# Memorandum to the City of Markham Committee of Adjustment

January 16, 2018

**Files:** A/161/17 – A/166/17  
**Address:** 6350 Steeles Avenue East, Markham  
**Owner:** Forest Bay Homes Ltd. (Lorne Leibel)  
**Agent:** Jamie Lopes (RN Design Ltd.)  
**Hearing Date:** Wednesday January 24, 2018

**DRAWING**  
SITE PLAN

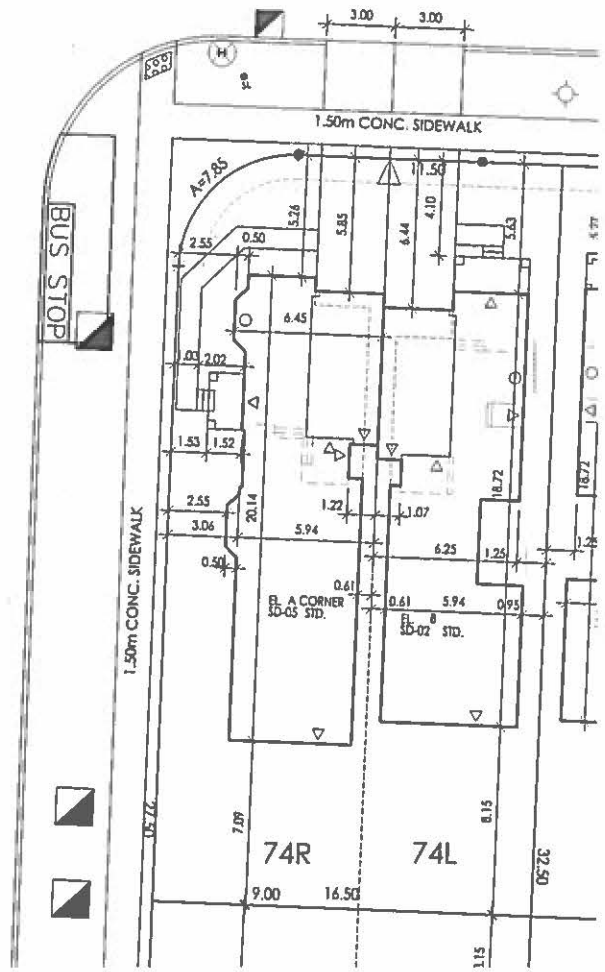
## **A/161/17 (part of lot 74) on Draft Plan of Subdivision 19TM-98019:**

a roofed porch encroachment of 1.52 metres, whereas the By-law permits a roofed porch encroachment of 0.45 metres into any required yard;

a step encroachment of 2.02 metres, whereas the By-law permits a step encroachment of 0.45 metres into any required yard;

a bay window encroachment of 0.5 metres, whereas the By-law does not permit a bay window encroachment.

CLIENT: Touchstone Homes  
PROJECT/LOCATION: Fairtree Markham  
DRAWING: SITE PLAN

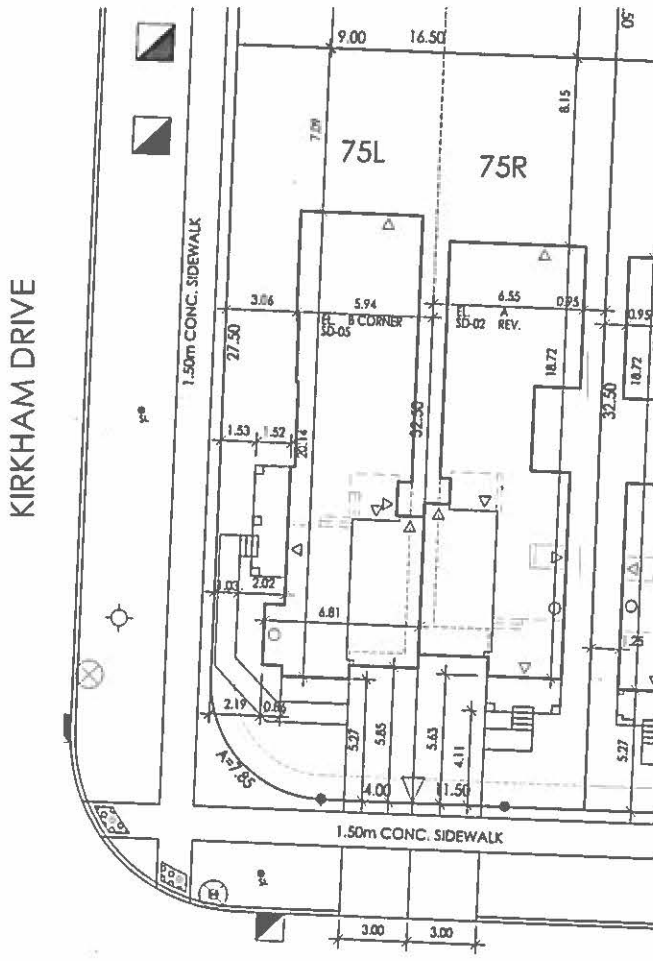
## **A/162/17 (part of lot 75) on Draft Plan of Subdivision 19TM-98019:**

a roofed porch encroachment of 1.52 metres, whereas the By-law permits a roofed porch encroachment of 0.45 metres into any required yard;

a step encroachment of 2.02 metres, whereas the By-law permits a step encroachment of 0.45 metres into any required yard;

a bay window encroachment of 0.86 metres, whereas the By-law does not permit a bay window encroachment.
